RECOMMENDATION MEETING

**9736 Greenwood Ave N.
Seattle, WA 98103**

3036290-LU

November 16, 2020

EXHIBIT 5: USES ALONG GREENWOOD AVE. N. AT STREET LEVEL.

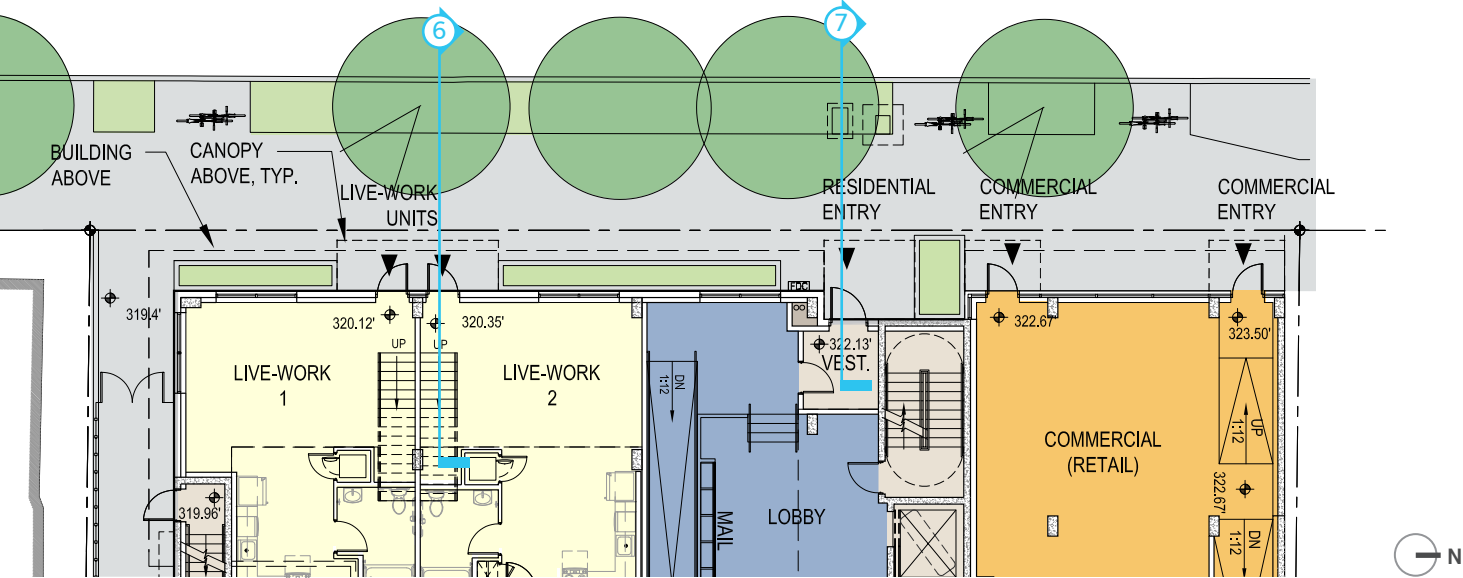
<p>b. Responding to public comment provided at the meeting, the board encouraged the applicant to incorporate secondary elements on the east facade to help break down the massing. The board members noted this facade was important as it faces Olympic View Drive and adjacent residences to the east and should not be considered a back of building condition. (DC2.c)</p>	<p>Regarding secondary elements on the east facade, wood composite panels are used to add visual interest to the balconies. Also, green screens, glass railings, light fixtures and a patterned application are provided on the concrete wall along the sidewalk. Glazing in windows and glass railings softens and provides a refined and attractive facade that relates well to the adjacent residences and does not portray a ‘back of building’ look.</p>	<p>See exhibit 3-4 on page 19.</p>
3	<p>STREETSCAPE:</p> <p>a. The board requested the applicant provide cross sections of the building’s street level interface along Greenwood Avenue in the recommendation packet. Greenwood Avenue, along the site’s frontage, has a minor slope to it. the board requested the cross sections to view how the different floor plates relate to the sidewalk. (CS1.c.2, CS2.b, pl1.b)</p>	<p>The proposed design incorporates different finished floor elevations at the entry for each use to ensure that all entries are at sidewalk grade with a direct accessible route to the spaces along the street. See cross sections shown.</p>	<p>See exhibit 5-8 on page 21-22.</p>

4	<p>ENTRIES</p> <p>a. The board noted the first-floor plan for the preferred option has separate entries for the live-work units, the residences on the upper floors, and the commercial space on the north side of the building. The board requested the applicant provide a sense of hierarchy between all three entries to distinguish them from one another. In addition to studying the entry hierarchy, the board requested the applicant study the location of the ground level uses related to entry locations, and design the entries to best serve each of the uses. (PL3.a, PL3.c, DC1.a)</p> <p>b. The board requested details for each entry along Greenwood Avenue and encouraged the applicant to design each entry to be at the sidewalk grade. The board noted the entries needed to be at grade to create a welcoming entry for pedestrians. If steps are required for the entry, the board requested the applicant provide a study for the ada accessible ramping to the entry for the board to consider in the recommendation packet. The study would demonstrate how ramping would work along the exterior of the building and maintain a welcoming entry. (CS1.c.2, DC3.a)</p>	<p>The entries to the residential lobby, live-work units and retail are distinguished by materiality. The use of glazing and wood composite material create the clear hierarchy. The residential entry is located in the west notch and is highlighted with the wood composite material. The softer material relates to the residential program. The live-work units utilizes the large transparent, expansive glazing that a typical non-residential program would require but accommodates the privacy that the residential unit would need with solid portions of wood composite panels and landscape planters. The combination of recessed entries and planters create a transition between the public and private realm, additionally, the commercial space is differentiated by having continuous glazing to increase transparency and visibility at all times.</p> <p>The proposed entries along Greenwood Ave N. are located at sidewalk grade with a direct accessible route (no ramps) and the finished floor elevation for each space is adjusted accordingly. See cross sections shown.</p>	<p>See exhibit 5-8, & renderings on pages 21-22, 40 & 41.</p>

EXHIBIT 9: USES ALONG OLYMPIC VIEW PL. N.

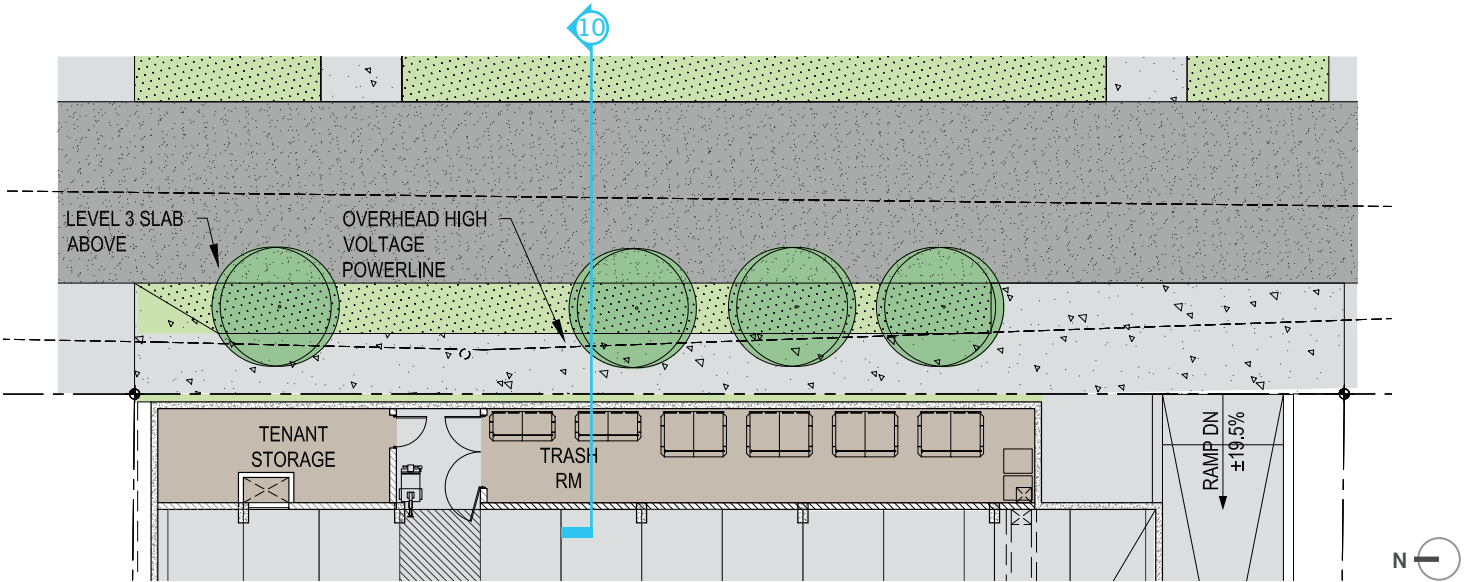
<p>c. The board expressed its concern with the wall condition at the sidewalk along Olympic View Drive noting that the landscape plan in the recommendation packet will need to include landscaping elements to break up the concrete wall condition. Responding to public comments at the meeting, the board also encouraged the applicant to balance the needs of privacy for the future residents of the building and safety and security concerns for pedestrians and neighbors along Olympic View Drive. to that end, the board requested the applicant provide details on the lighting proposed along Olympic View Drive in the recommendation packet. (CS2.b, DC4.c, PL2.b)</p>	<p>The proposed design for the wall along Olympic View Pl. N. utilizes a flowy, nature related concrete patterning. The addition of vertical green screens softens the overall appearance and breaks down the length of the wall segments. Landscaping at grade along the sidewalk also helps soften the concrete wall. The proposed glass railing on the courtyard also provides security and eyes on Olympic View Pl N. Lighting is provided on the wall along the sidewalk. Additional landscaping in the courtyard helps to create a buffer for privacy to building residents. See cross sections shown.</p>	<p>See exhibit 3-4, 9-10 & landscape plan on pages 19, 22 & 30-31.</p>

18.0 PRIVACY STUDY: NORTH FACADE

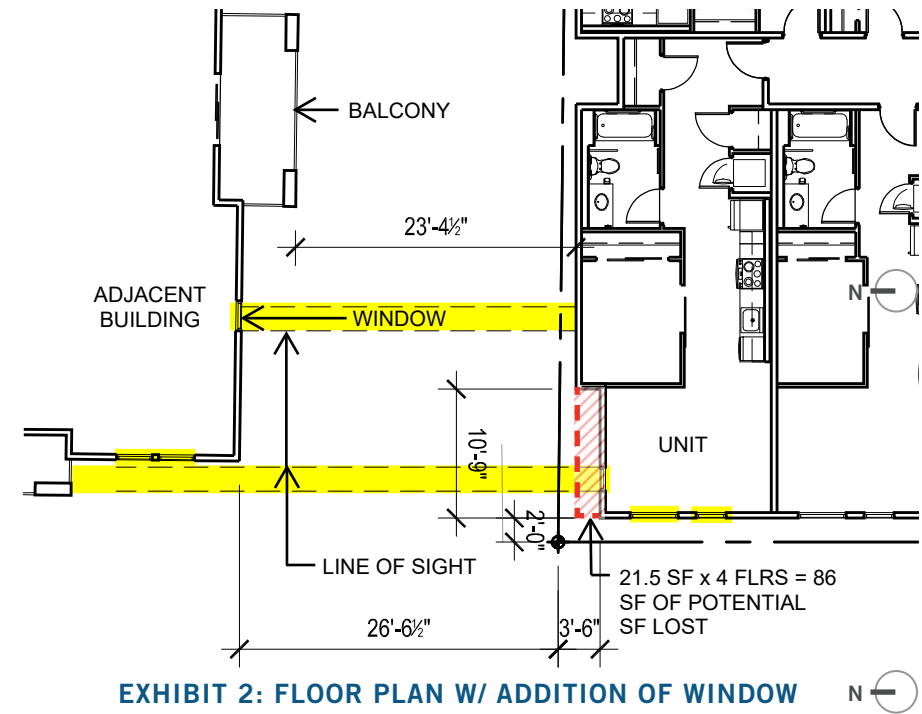
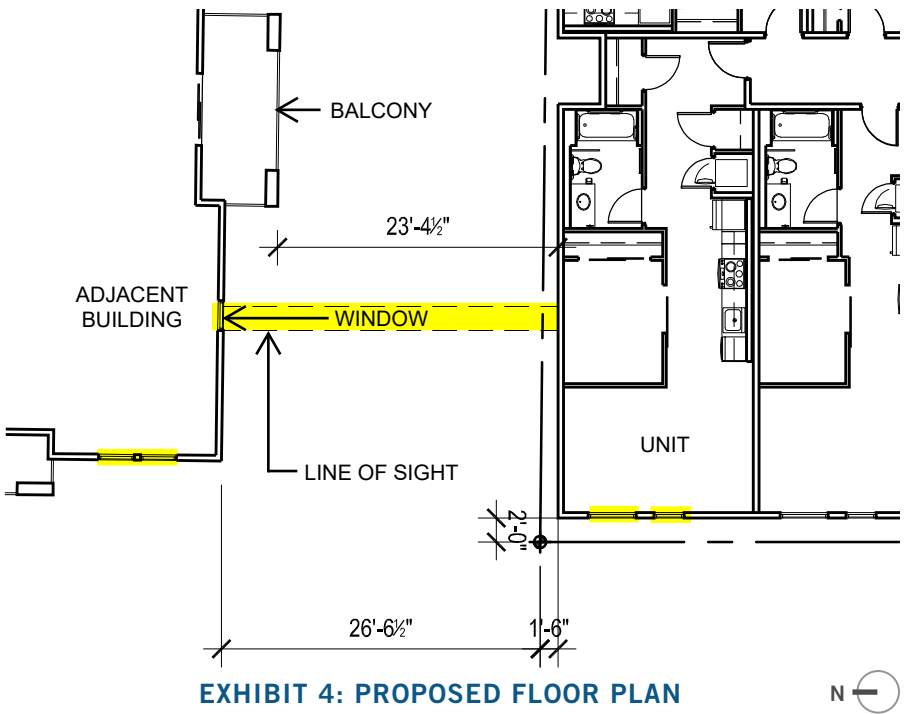
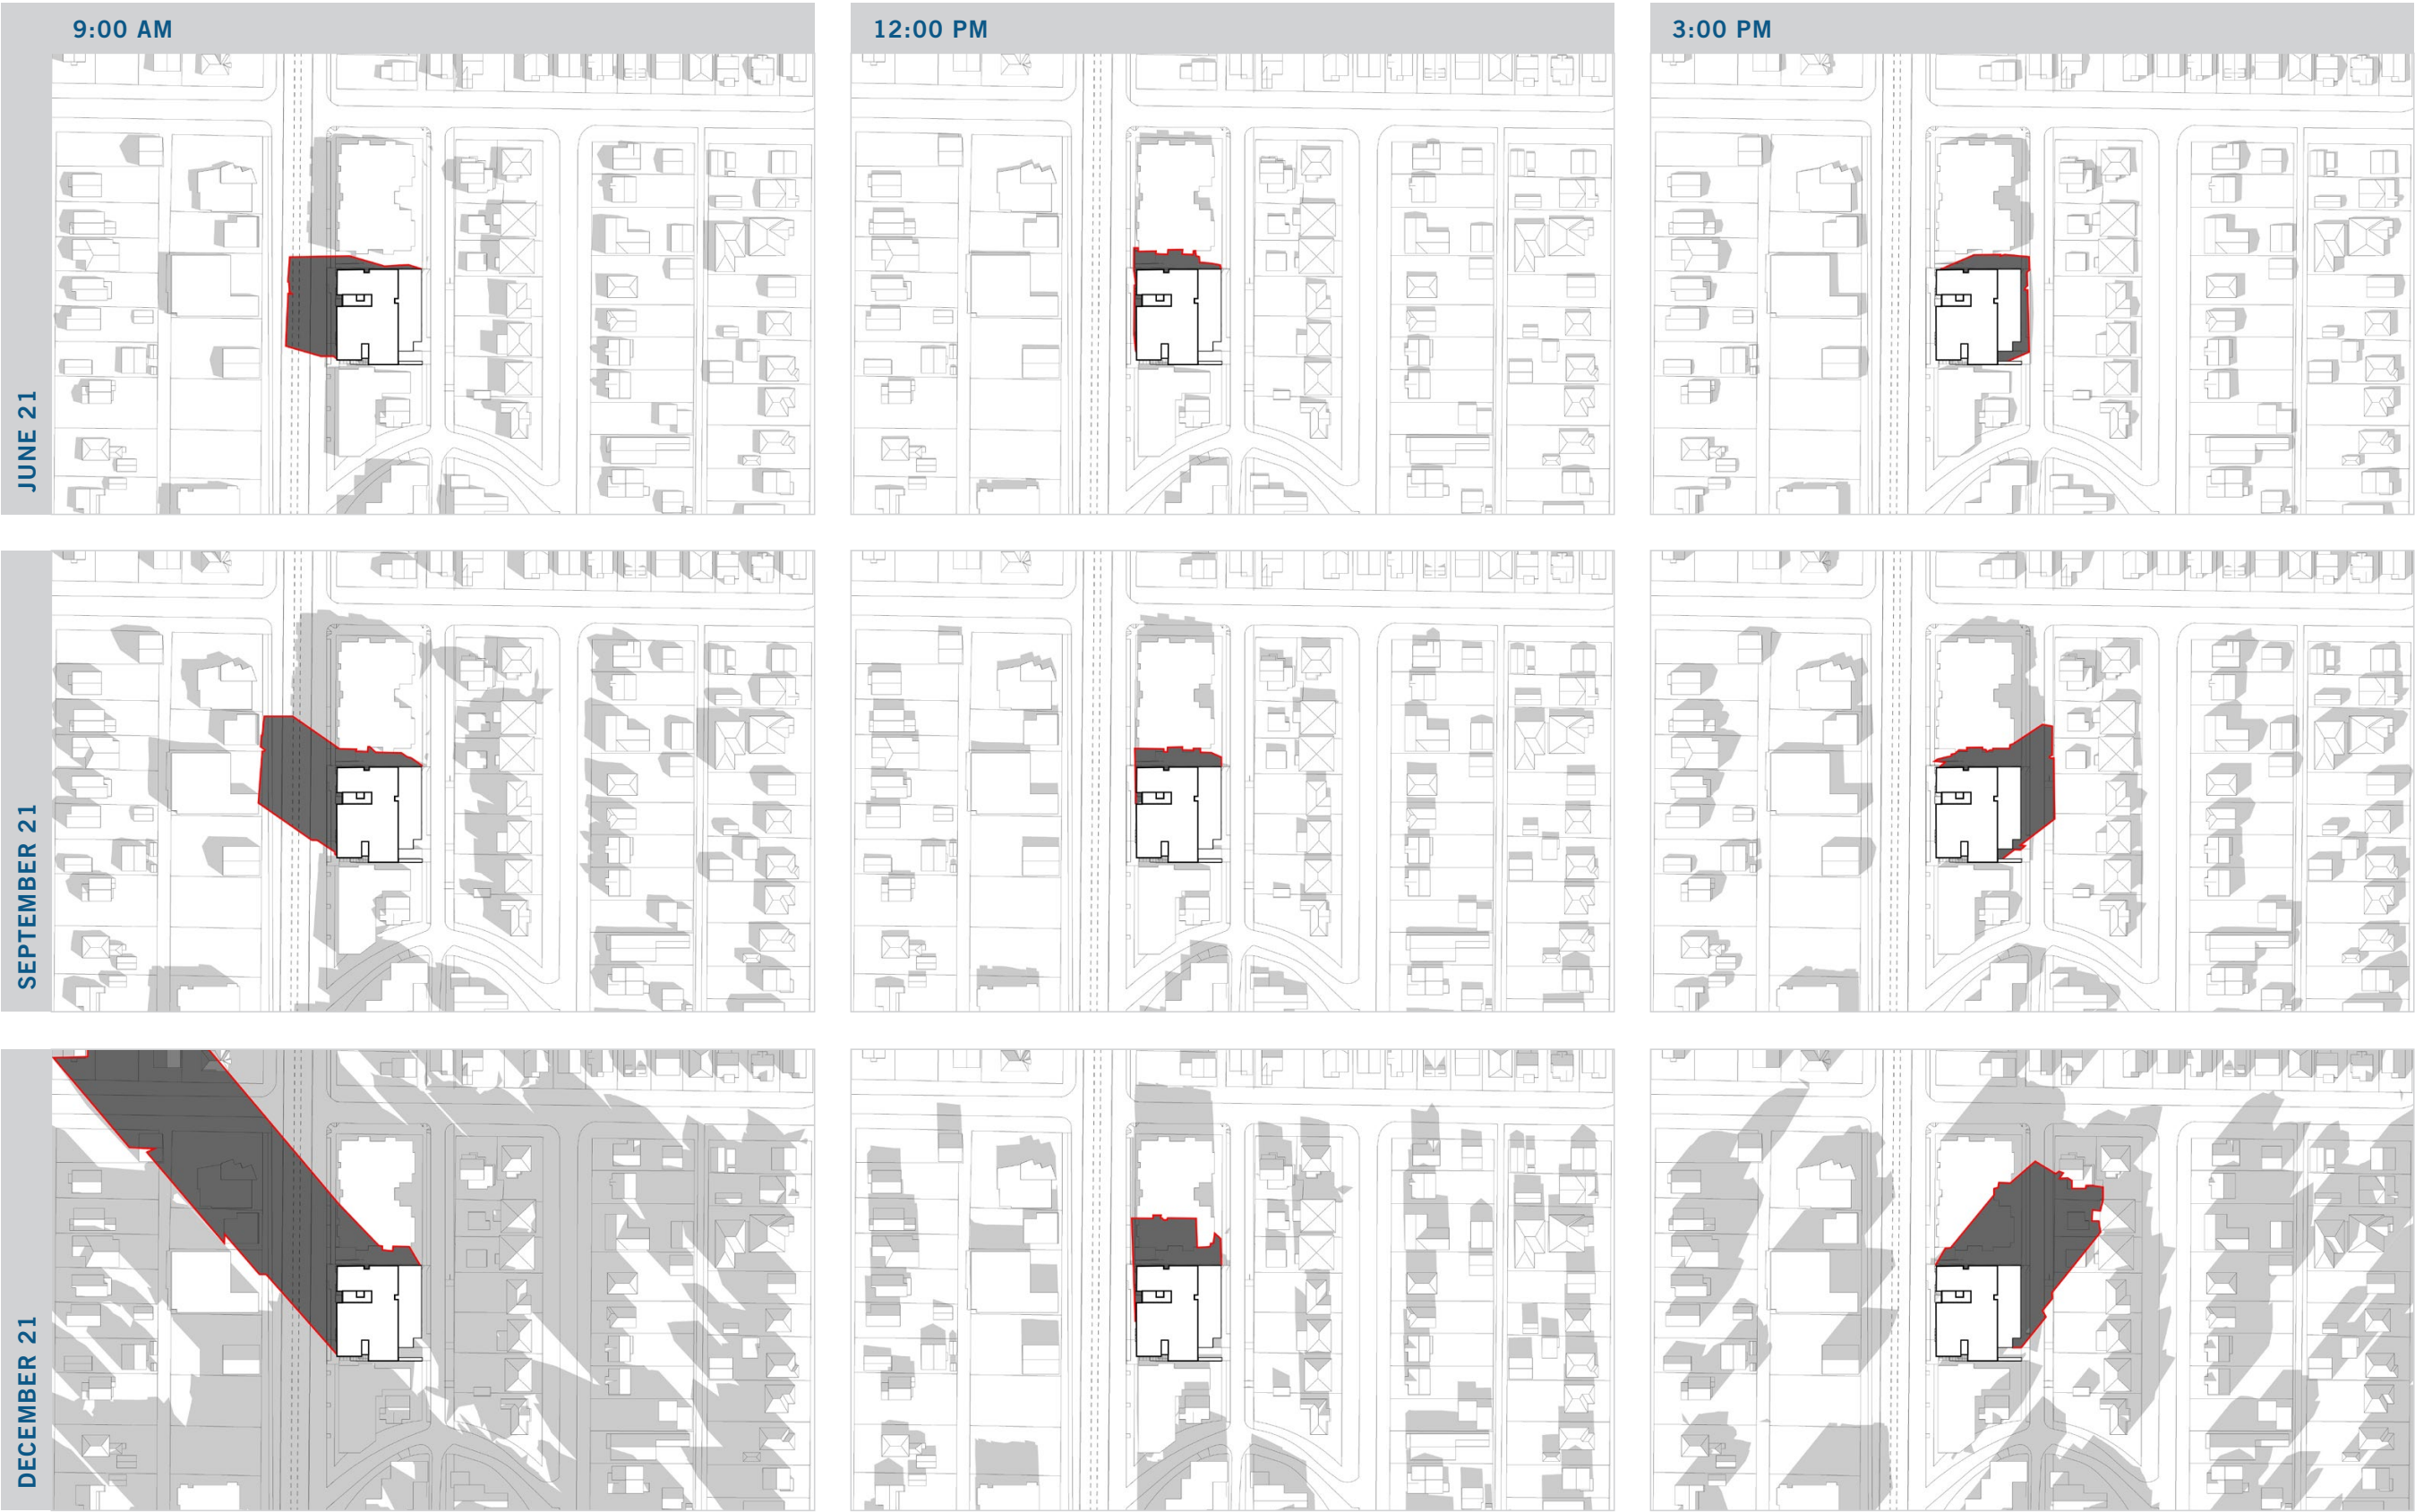
BOARD RECOMMENDATIONS		DESIGN TEAM RESPONSE	REFERENCE
2	<p>BLANK WALL:</p> <p>a. The board members raised concerns about the north and south walls of the building being potentially blank walls, noting that the north wall will be highly visible to both the public and residents of the building immediately north of the site. In addition to the blank wall concerns on the north wall, the board requested the applicant include a privacy study in the recommendation packet due to this existing apartment north of the site. The board members also noted the south wall condition as being a potential concern, however, acknowledged that any blank wall condition will not be as significant since redevelopment of the site to the south, when it occurs, will likely block any blank wall condition. (DC2.b)</p>	<p>The north facade incorporates two elements that addresses the board’s concerns. The first element is the use of darker gray panels arranged in a ‘playful’ random pattern to create interest. The second is the introduction of a north notch with wood composite panels to break up the scale of the facade.</p> <p>The south facade incorporates a similar material application that is used on the west and east facade with striped darker gray panels and the wood composite accent panels. The addition of windows on the south west side of the building allows for the treatment of the west facade to wrap around the southwest corner and prevent a blank wall. The notches on the north and south break down the massing of both facades and are further highlighted with the use of wood composite panels.</p> <p>The neighboring building to the north has a number of openings on their south facade, directly facing the proposed building. No windows are proposed on the north facade due to privacy issues; a privacy study is provided.</p>	<p>See elevations & privacy study on pages 34-37 & 56.</p>

At EDG, the board raised concerns about the blank wall on the north facade. The purpose of this privacy study is to present the limitations of adding openings to the north facade of the proposed building as well as to show that the proposed design without windows on the north facade is a better solution.

Hence the study explores the addition of 2’ x 7’ windows at each level similar to the windows on the south facade, placed at the NW corner in an area with maximum separation from the adjacent building and without any south facing windows in the adjacent building in the direct line of sight. The fire separation distance of 3’-6” shown at the NW corner was most reasonable without an excessive reduction of square footage inside the unit. See Exhibit 2 & 3.

Although, the addition of windows can be a solution to a blank facade, the proximity of the north facade to the property line and the location of multiple windows on the south facade of the adjacent building prevent a situation where the pros outweigh the cons. The proposed building has simple and clean massing that was supported by the board at EDG. The proposed massing and floor plan layout allows the units to rely on guaranteed light and ventilation from the east and west facades facing the streets versus windows facing the side lot line. It also allows for the retention of interior space that is valuable to the potential tenants. See Exhibit 4 & 5.
